HITACHI BULLETIN

M1LXU & A3LXU POWER SUPPLY

TECHNICAL BULLETIN - BULLETIN TECHNIQUE

No. TB0240

SUBJECT/SUJET: CONVERGENCE PROBLEM CAUSED BY IC1105.

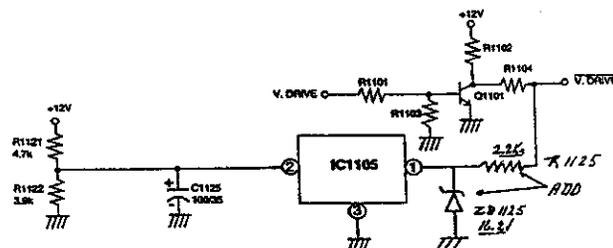
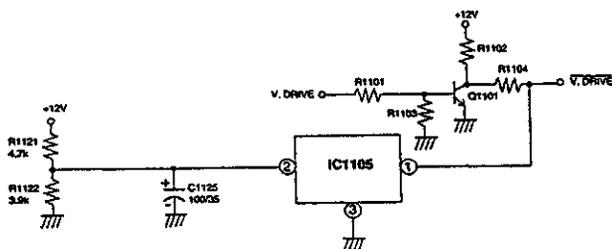
When IC1105 is replaced, the following modification should be performed:

IC1105 is located in IC1101 location on PCB. Also, IC1105 Pin numbering is reversed of PCB diagram.

R1125 (2.2KΩ 1/16W) should be installed in series with Pin #1 of IC1105 (Part # 0700045)

ZD1125 (16.2Volts) should be installed parallel with Pin 1 and 3 of IC1105 (Part # 2334243)

SUBJECT/SUJET: SHUTDOWN PROBLEM - MODEL 27CX5 - 27CX25 CHASSIS M3LXU

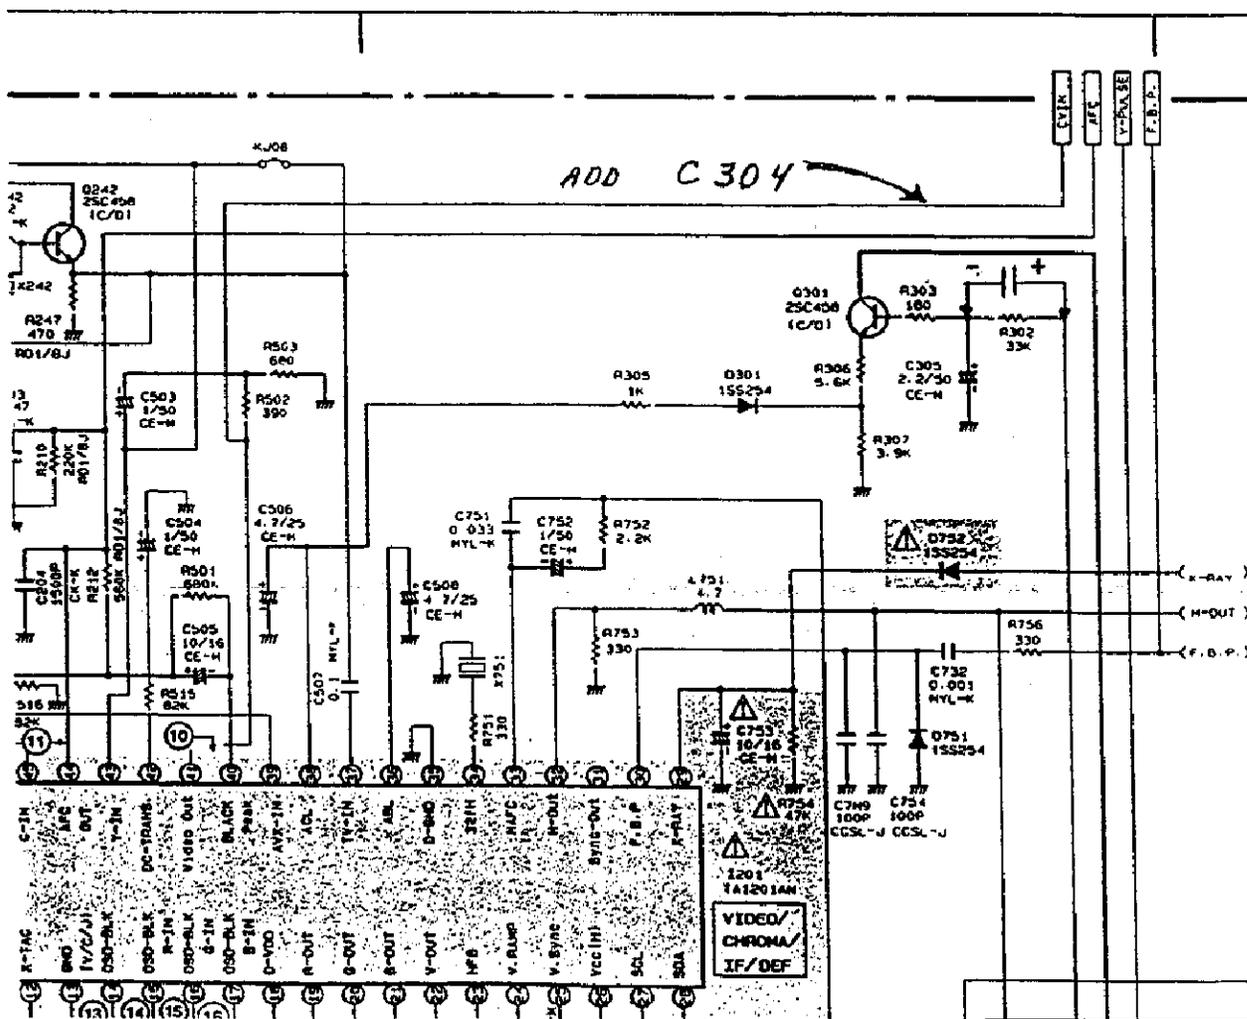
If you have experienced a shutdown problem with either of the above mentioned models, please add capacitor C304 - 0.47µF/50V. (Part # 0800001) parallel to R302, and secure with silicone glue.

The physical location on the PCB of R302 is between vertical section and video audio auxiliary jack. See diagram below.

SUBJECT/SUJET: MODEL 27CX5 - 27CX25 CHASSIS M3LXU

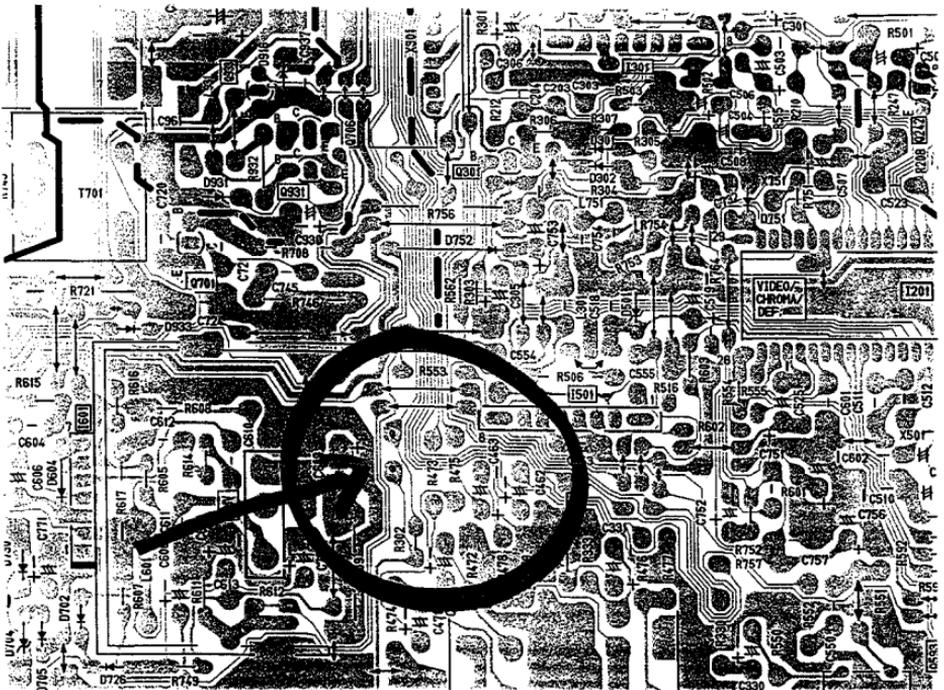
We recommend using the 2 existing holes to install the C304 and installing the capacitor on the component side (see diagram below).

SUBJECT/SUJET: BLANK OR DELAYED PICTURE WHEN ON PinP SELECTION.

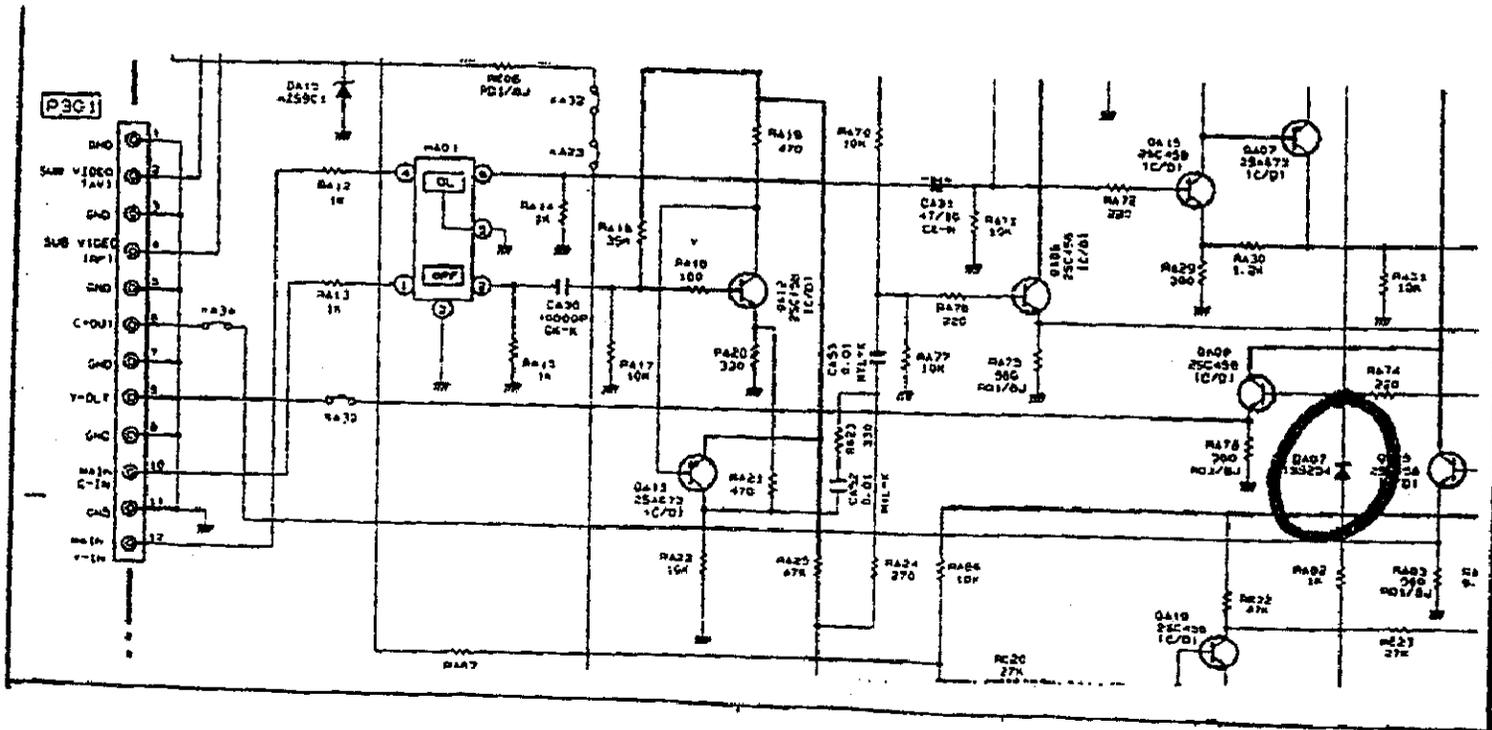
Picture stays blank or is delayed when the signal of PinP (auxiliary input) is changed and unit is in SWAP mode.

Delete diode DA07 from PinP PWB. Schematic diagram below: -
